## Application for Licence Amendment

### Part V Division 3 of the *Environmental Protection Act 1986*

<b>Licence Number</b>	L9430/2024/1
<b>Licence Holder</b>	Onslow Iron Pty Ltd
<b>ACN</b>	649 012 395
<b>File Number</b>	DER2024/000061
<b>Premises</b>	West Pilbara Iron Ore Project  M08/480, M08/484, G08/88, L08/67, L08/68, L08/69 and L08/181  CANE WA 6710  As defined by the Premises maps attached to the Revised Licence
<b>Date of Report</b>	23 August 2024 (FINAL)
<b>Proposed Decision</b>	Revised licence granted

Figure 2: Distance to sensitive receptors

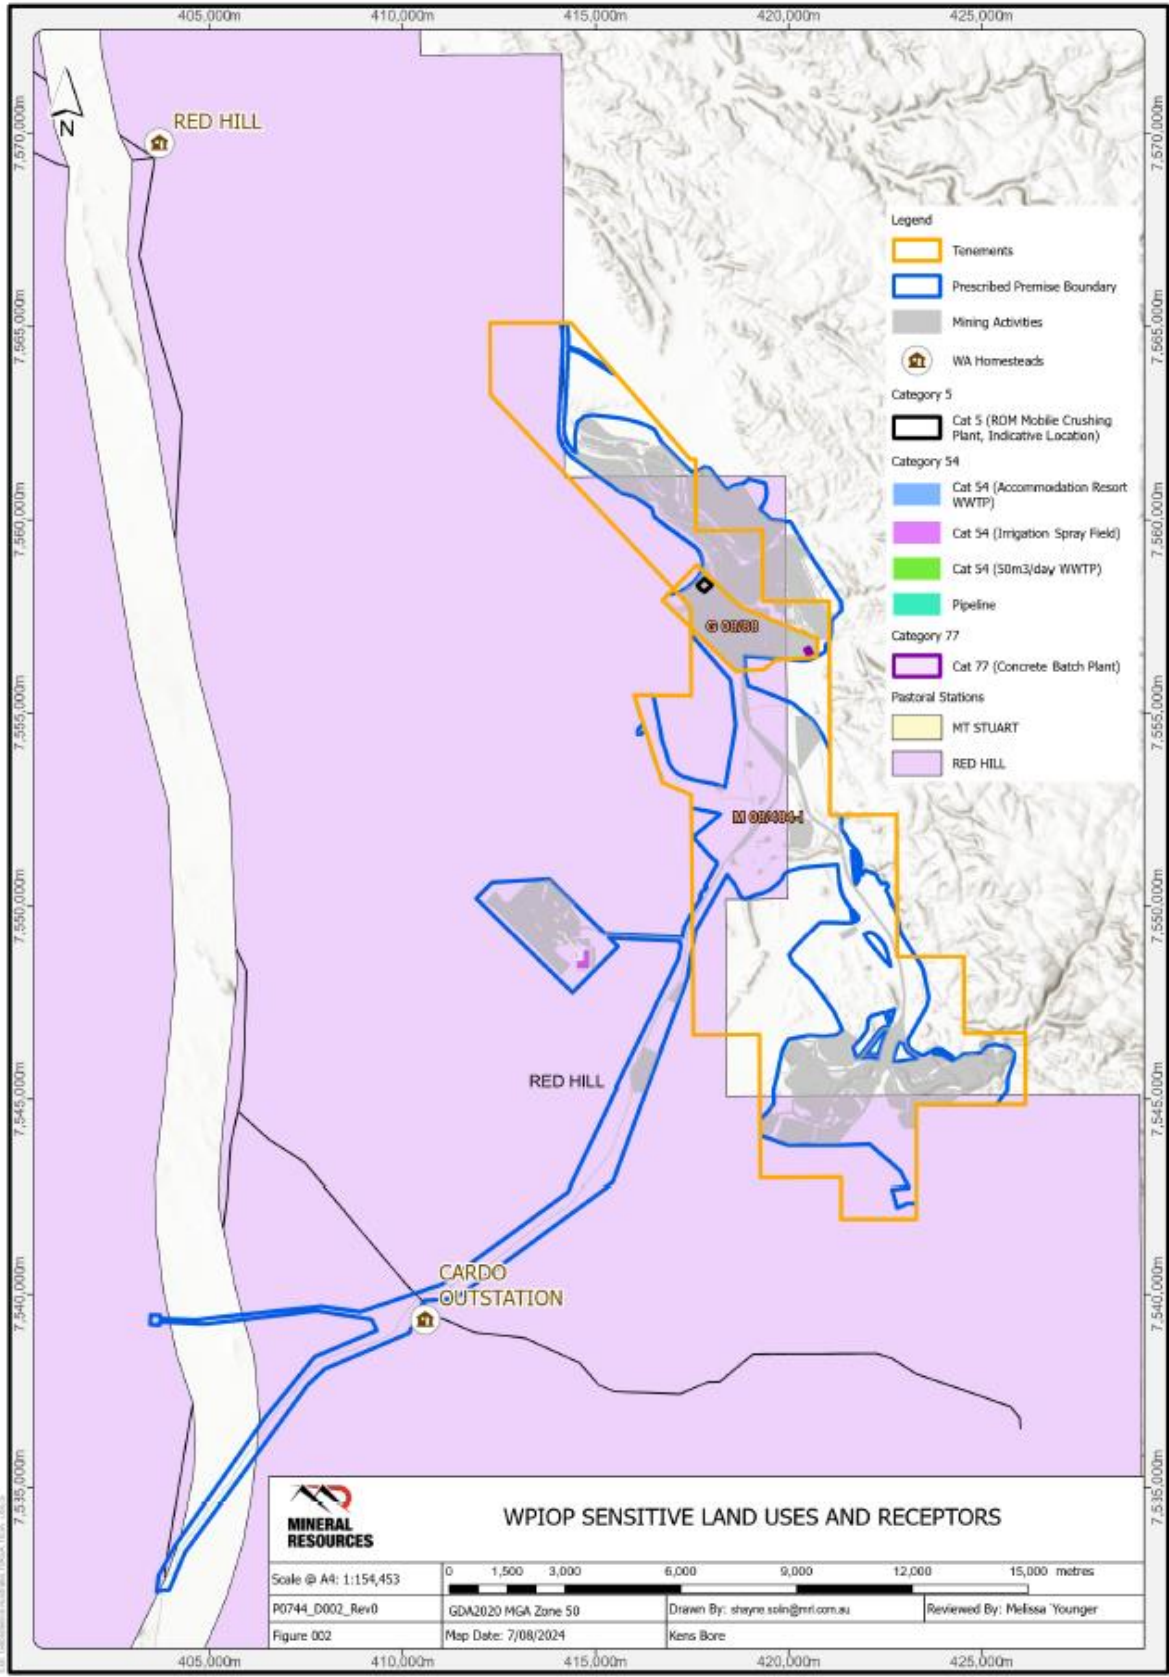
Section 3.1.1, Table 3 Section 3.2, Table 5	Note that: - Condition 7-7 of MS1203 replaces Condition 7-7 of MS 1027. - The Northern Quoll Management Plan and the Pilbara Olive Python Management Plan are requirements of EPBC Decision Report 2009/4706	Updated as requested.
Figure 2	A revised Figure 2 is attached.	Updated as requested.
